Australian Turf Club and Sydney's Light Rail project: Urban Impact Summary document- 18.12.2013

Sydney's Lightrail: Impacts Summary Sheet

CBD & SOUTH EAST LIGHT RAIL PROJECT

Figure 15: Proposed Conditions – Alison Road (Darley Road to Wansey Road)

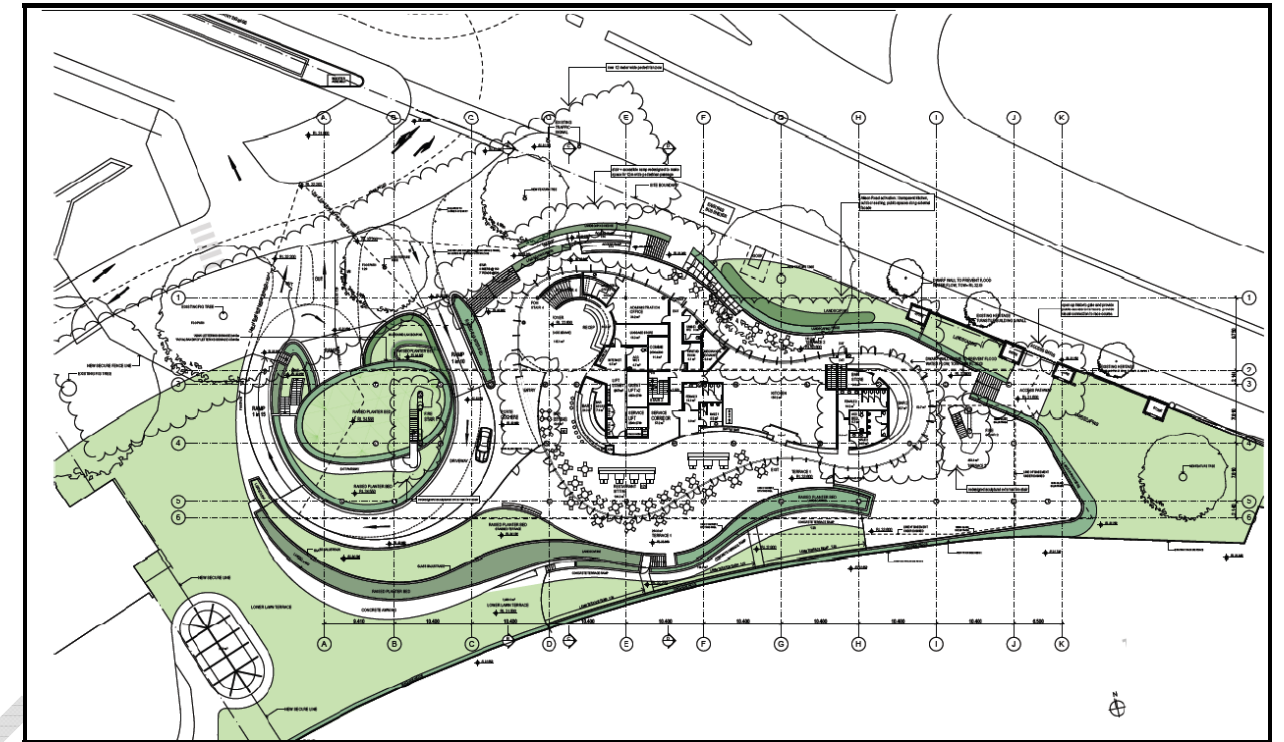
Category	Sub-Category	Proposed Conditions	Discussion / Comment	Road Safety Risk/s
Consistency	-	-	-	-
Layout	Track Location	Light rail tracks located on southern side of Alison Road.	n/a	n/a
	Platform Size	-	-	-
	Storage	-	-	-
	Swept Paths	-	-	-
Access	Crossing Points	No details of how pedestrians will cross light rail tracks.	At Darley Road, John Street and Cowper Street, there are no details of how pedestrians will cross the light rail tracks. In addition, there is no storage area between the Alison Road traffic lanes and the light rail tracks, nor between the shared path and the light rail tracks.	No pedestrian storage areas between traffic lanes, light rail tracks and shared path.
	Ramps	-	-	-
	Illegal Access	No indication of any proposed fencing between Alison Road, tracks and shared path.	Existing busway along Alison Road has fencing on both sides with openings at bus stops. Fencing may be required along Alison Road due to high speed LRV passing pedestrians and cyclists in the opposite direction. Openings could be provided at intersections.	Conflicts between high speed LRV and pedestrians and cyclists using shared path.

Safety	-	-	-
	Footpath / Shared Path	Proposed shared path on south side of tracks.	Separated shared path will provide a high standard facility in terms of safety and operation.	n/a
	Vehicle	There are a number of existing access gates to the Royal Randwick Precinct.	There are no details regarding the retention or removal of these access gates, and if retained, how vehicles will be able to cross the light rail tracks and shared path.	Safe crossings of the light rail tracks and shared path at access gates.
Intermodal	Sharing of Tracks	-	-	-
	Bus Stops	There is an existing bus stop on the south side of Alison Road near Darley Road.	There is no indication if the bus stop will be retained (and there is no room between the tracks and Alison Road).	Location and access to bus stop.
	Bus / LRV Transfer	-	-	-
	Bus Priority	-	-	-
Signal Operation	Overview	-	-	-
	LRV Movements	-	-	-
	Bus Movements	-	-	-
	Pedestrian Movements	-	-	-

Figure 24: Proposed Conditions - Wansey Road / High Street

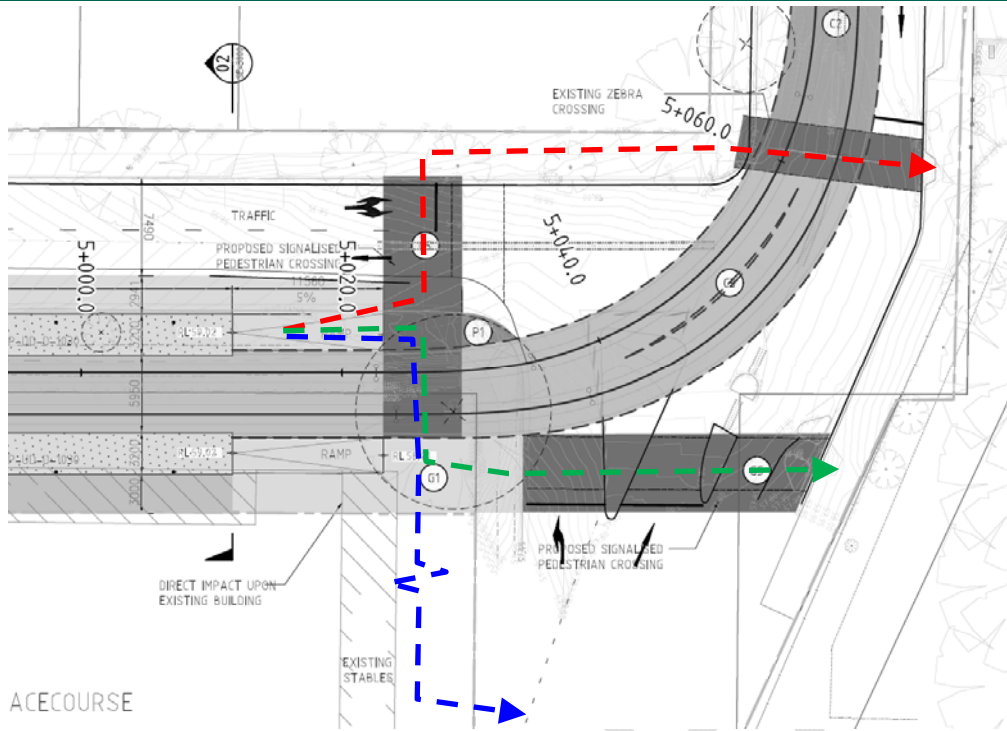
Category	Sub-Category	Proposed Conditions	Discussion / Comment	Road Safety Risk/s
Consistency	-	-	The 'Road Engineering' plans and the 'Stop Plans' show different configurations for the pedestrian crossings. It has been assumed that the Stop Plans are the basis for comment.	Update plans to be consistent.
Location	Surrounding Land Uses	Located at north east corner of UNSW campus, on north side of High Street.	Proposed stop is located adjacent to UNSW campus, a major passenger generator.	Not enough room in High Street to locate tracks, stops and traffic lanes.
	Land Acquisition	Required from Royal Randwick Precinct on west side of Wansey Road.	n/a	n/a
Layout	Track Location	Tracks located on west side of Wansey Rd and centre of High Street.	Track curves require tracks to be located on west side of Wansey Road. Additional land acquisition would be required from residential properties on north east corner of intersection to realign track curves.	n/a

Storage	Ramps provided at both north and south ends to provide access.	Ramps and approaches will provide additional storage if stops are congested. Road safety risk is if pax cannot clear light rail tracks or roads. As the citybound stop will have the highest boarding numbers, the ramp and large storage area is expected to accommodate all required pax without queuing across the light rail tracks and roads.	n/a
	Swept Paths	The proposed tracks and stops will reduce the width of Wansey Road and High Street.	<p>North to east left turns (from Wansey in to High) – very tight radius, turning vehicles may encroach on to citybound light rail tracks.</p> <div data-bbox="1003 1381 2166 1837" data-label="Text"> <p>DRAFT</p> </div>	Ensure design vehicles able to undertake turn. If cannot undertake turn, stop line on east leg of intersection may need to be set back.
			West to north left turns (from High in to Wansey) – very tight radius, turning vehicles may encroach on to southbound traffic lane or mount footpath, potential conflict with pedestrians if right turners allowed turn at same time as pedestrians.	Ensure design vehicles able to undertake turn. If cannot undertake turn, consider removal of the left turn slip lane and allow left turns from the eastbound 'through' lane. The left

Category	Sub-Category	Proposed Conditions	Discussion / Comment	Road Safety Risk/s
				turn slip lane could then be used as a larger pedestrian area and reduce the width of the crossing across the west leg of the intersection. The Wansey Road stop line could then also be moved further south.
			North to east right turns (from Wansey in to High) – very tight radius, turning vehicles may encroach on to waiting areas, may impact on parking along High Street, potential conflict with pedestrians if right turners allowed turn at same time as pedestrians.	Ensure design vehicles able to undertake turn. Review conflict with pedestrians – consider early start for pedestrians on crossing.
			LRV clearances increase around tight radii. Turning LRV may encroach in to pedestrian crosswalks and waiting areas.	Ensure adequate clearances to turning LRV around curves and modify crosswalks and waiting areas to suit.

Westbound through movements have poor delineation through intersection.	Build out southern side of High Street out to existing kerb outstand.
Access	Crossing Points	<p>The 'Road Engineering' plans and the 'Stop Plans' show different configurations for the pedestrian crossings.</p> <p>Signalised Pedestrian Crossings are proposed at Wansey Rd/High St intersection, across Light rail tracks (at north and south ends) and also across Wansey Rd at north end of stops.</p>	<p>A key design consideration must be the movement of pedestrians to and from the stops. In the AM Peak, there will be a very high movement of pedestrians from the southbound platform, down the ramp, and then across the roads at the signalised access points. Even though these movements are to be controlled by signals, it is expected that pedestrians will cross the tracks and roads against the signals. Therefore, although signalised crossings are required for the road crossings, the crossings of the tracks should be 'LRV priority crossings' which will allow pedestrians to cross as required except for when LRV are present.</p> <p>As the stops are located on the north side of High Street, pedestrians to UNSW will be required to either:</p> <ul style="list-style-type: none"> ▪ cross Wansey Road and High Street, ▪ cross tracks then High Street, or ▪ cross tracks, walk westbound along High Street then cross at zebra crossing. 	<p>Agree that road crossings should be signalised.</p> <p>Recommend that crossings of the tracks should be unsignalised with priority given to LRV. Electronic signs could be used to provide increased warning of an approaching LRV e.g. 'GIVE WAY TO LIGHT RAIL VEHICLE'</p> <p>The removal of the left turn slip lane could increase the storage areas for pedestrians and reduce the crossing width.</p> <p>The southbound shared path ends just north of High Street. Shared path users will need to share this space with large numbers of pedestrians. Provide a surface treatment that clearly delineates the end of the shared path and warns of pedestrians.</p> <p>Consider an alternative access down northern side of High Street to a new pedestrian overpass to provide direct connection in to UNSW campus.</p>

Category	Sub-Category	Proposed Conditions	Discussion / Comment	Road Safety Risk/s
			 <p>It is noted that the existing zebra crossing on High Street to the west of the Wansey Road intersection (as shown in Figure 21) is used by a large number of pedestrians (mostly bus passengers) and UNSW has safety concerns regarding its operation. Adjacent to this zebra crossing is a raised walkway into UNSW's grounds. A potential future option is to create a pedestrian overpass (to replace the zebra crossing) that connects directly to the raised walkway within UNSW. This option would mean that a significant number of LRV pax would only have to cross the tracks and no roads.</p>	
	Ramps	DDA compliant ramps provided at both north and south ends to provide access.	The ramps end at the crossing points which may create congestion as pedestrians wait to cross the tracks or Wansey Rd.	Shorten ramps if possible to create larger waiting areas prior to cross points.

Illegal Access	No fencing has been shown.	The crossing at northern end important to provide access to from residential area and park and ride. Illegal or undesirable crossings are expected to occur between the shared path, track and park and ride footpath (especially during the AM Peak).	Install fence between shared path and tracks (to protect shared path users from opposing LRV), and between park and ride footpath and tracks (to prevent pedestrians crossing tracks away from formal crossing points).
	Safety	-	Illegal access is the main safety issue as discussed above.	n/a
	Footpath / Shared Path	4.0m shared path on Wansey Road narrows to 3.0m past platform.	Shared path ends at southern end of platform. Shared path users, especially cyclists, will enter an area with significant numbers of pedestrians.	Nil – 3.0m is desirable width for shared path. Ensure path material and signage indicate end of shared path. Consider installation of bicycle lanterns for crossing of High Street to allow cyclists to cross without dismounting.

Vehicle	No vehicle access proposed.	University access restricted to left in/left out. No vehicle access to Royal Randwick Precinct shown on plan.	Access to Royal Randwick Precinct.
Intermodal	Sharing of Tracks	-	n/a	n/a
	Bus Stops	Westbound bus stops (indented bays) proposed on south side of High Street east of intersection.	Proposed stop will replace a number of existing bus stops in High Street.	n/a
		Eastbound bus stops retained on north side of High Street west of intersection.	Nil.	n/a
	Bus / LRV	-	It is noted that some bus stops will be retained, and passengers may transfer to LRV. These passengers likely to	n/a

Category	Sub-Category	Proposed Conditions	Discussion / Comment	Road Safety Risk/s
	Transfer		cross High Street then Wansey Road.	
	Bus Priority	No bus priority shown on plans.	LRV and pedestrian priority likely to be highest priorities, so unlikely to be able to also provide bus priority. In addition, buses will not be located in separate lanes so additional priority unlikely to be effective.	n/a
Signal Operation	Overview	No details provided.	<p>Separate phases likely to be required for High Street throughs, Wansey Road left/right, and tram movements. Some other movements (vehicle and pedestrian) could run with LRV phases. Some traffic movements conflict with pedestrian movements.</p> 	Review phasing to determine optimal operation for LRV and pedestrians.
	LRV Movements		<p>Signalised left and right turn movements. LRV movements could run separately. May not want green for pedestrians across Wansey Road at same time as LRV movements as pedestrians may observe green walk signal and think it applies to the crossing of the tracks.</p> <p>Need to determine southbound trams 'trigger' signals. The time at stops is variable and only want to provide time to LRV phases when needed. Providing advance detection of east leg will be possible. Advance detection on north leg not possible due to proximity of stop. So when LRV detected, need to be able to 'close' down other phases as quickly as possible. The restriction on closing down phases will be pedestrian crossing clearance times. If pedestrian crossing can be as short as possible, this reduces the time required to 'stop' the pedestrian phase and switch to the LRV phase.</p>	<p>If crossing of Wansey Road is signalised and crossing of tracks is not, stagger the crossings so that pedestrians are required to change direction.</p> <p>Modify intersection to increase distance between light rail stop and crossing point to allow detection of southbound LRV.</p> <p>Modify intersection to reduce length of the pedestrian crossings.</p> <p>Signal operation should be set up to allow LRV phase to run between other phases to reduce delays.</p>

Figure 2.1 - Typical section through Wansey Road Stop (sourced from EIS Figure 10.5).

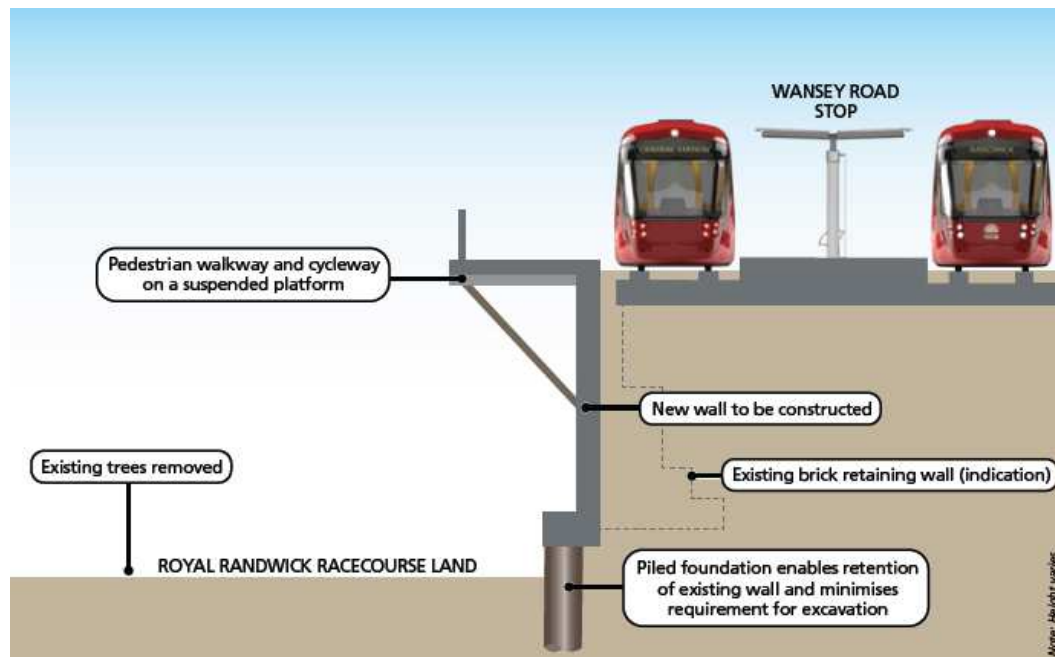
EIS is contradictory on the proposed retaining solution. It is understood that the engineered solution is to be the piled and reinforced concrete retaining wall (as illustrated in Figure 5.48 of the EIS).

A fence providing screening of Royal Randwick Racecourse (RRR) is required from the suspended path to horse training and stabling areas.

RRR vehicle clearances from suspended path to be considered. A vehicle exclusion zone is likely to be required to prevent impacts on the structure. This may impact RRR circulation.

Figure 2.4 – RRR impacts at Stabling Yard and RRR Stop.

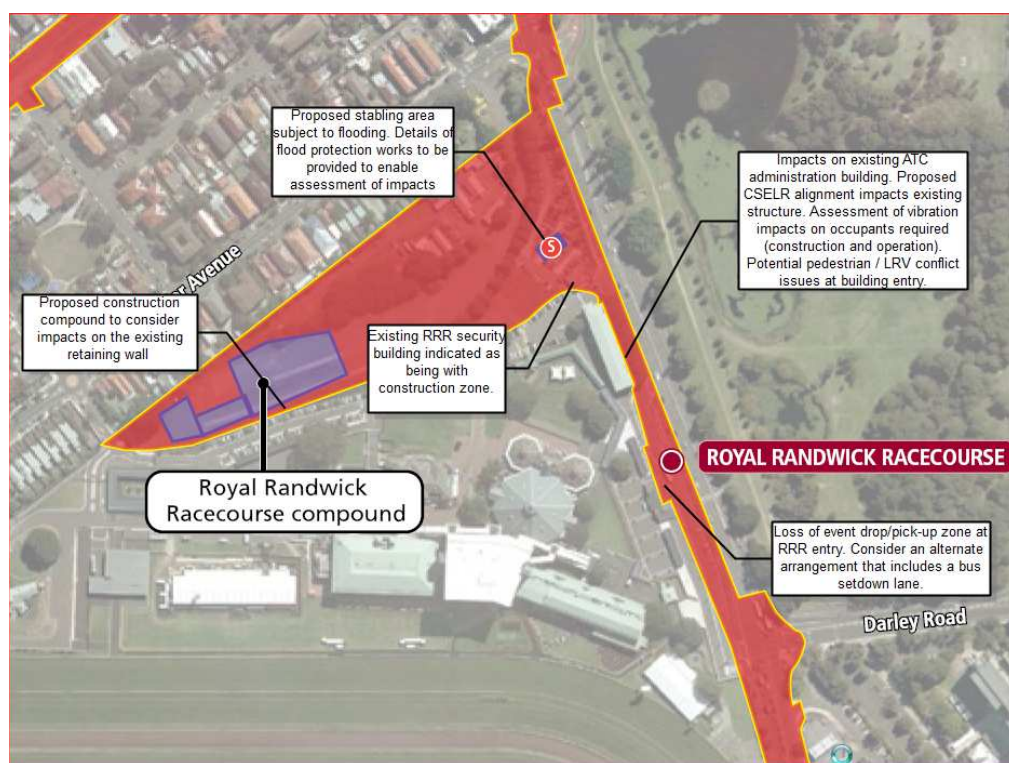
EIS notes upgrading the downstream drainage network is noted as potential solution. This may be too large and costly solution for TfNSW. Construction of stabling yards, and filling site for flood protection, in what appears to be flood backwaters, may cause flood impacts elsewhere. EIS notes detention as option. This is likely to be a significant volume (to replace lost flood storage volume) and there may be issues getting a hydraulic solution that does not involve pumping.

Figure 2.5 – Proposed stabling yard facility with RRR.

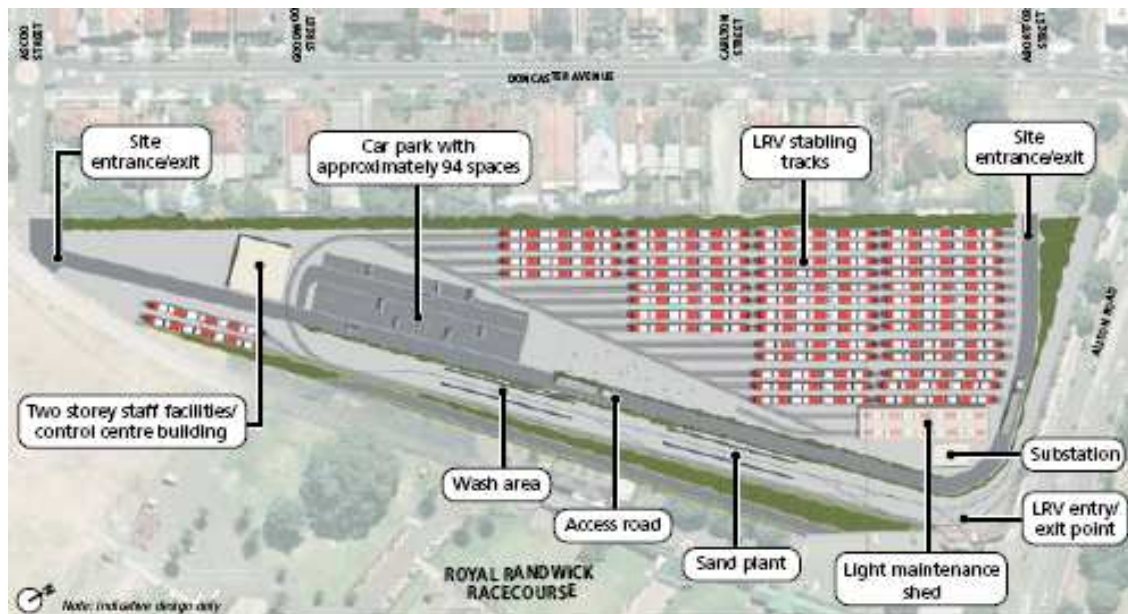
Consider impact and possible mitigation measures to protect aquifer against contamination during construction. Noting also that site is subject to flooding.

Figure 2.6 –Proposed UAP future built form within ATC lands (sourced from <http://www.planning.nsw.gov.au>).

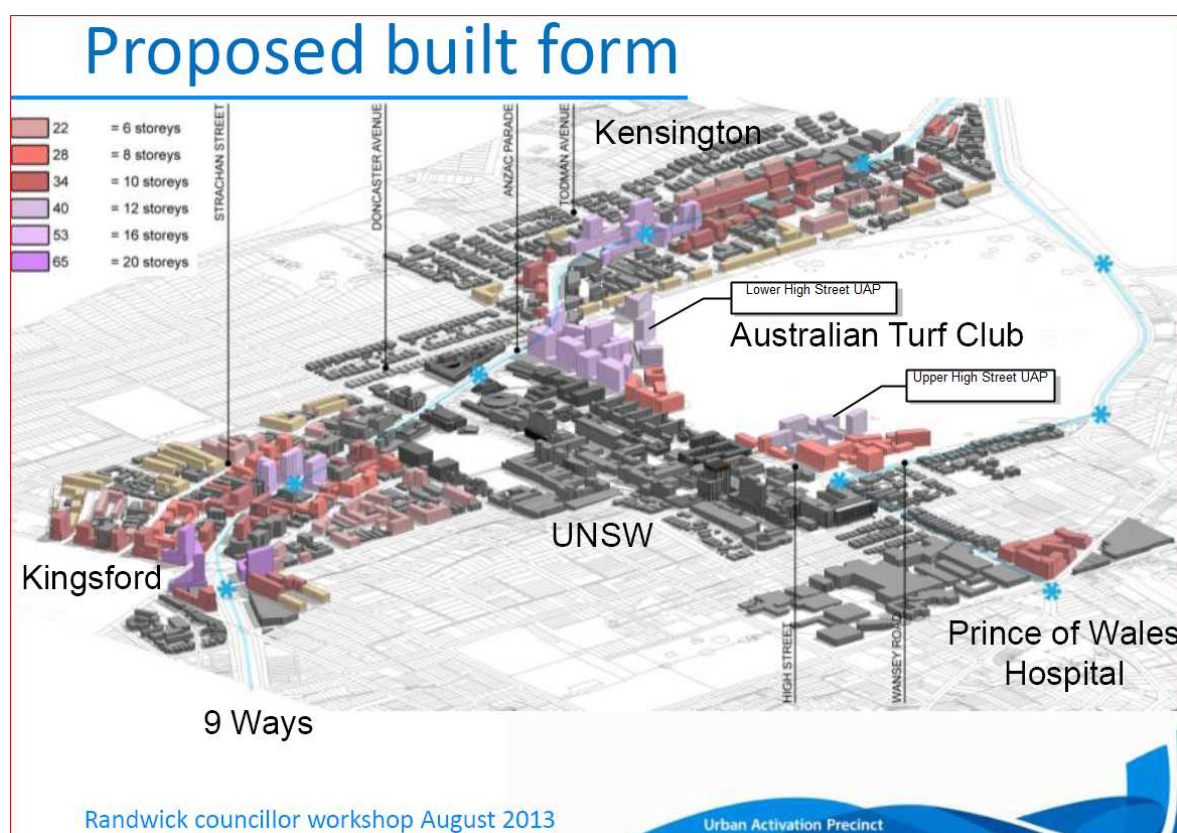
The CSELR proposal may constrain access and servicing to future UAP sites within ATC lands and impact development potential. Current UAP built form densities/heights are indicated in Figure 2.7 below.

- Civil and structural design and construction of the light rail must allow for heavy vehicle crossovers at all existing entrances and exits.
- Civil and structural design and construction of the light rail must allow for heavy vehicle crossovers to approved developments and future urban activation precincts (UAP).
- The engineering of the track and all associated retaining structures must be engineered and co-ordinated with authorities to cater for services penetrations, existing and future provisions.
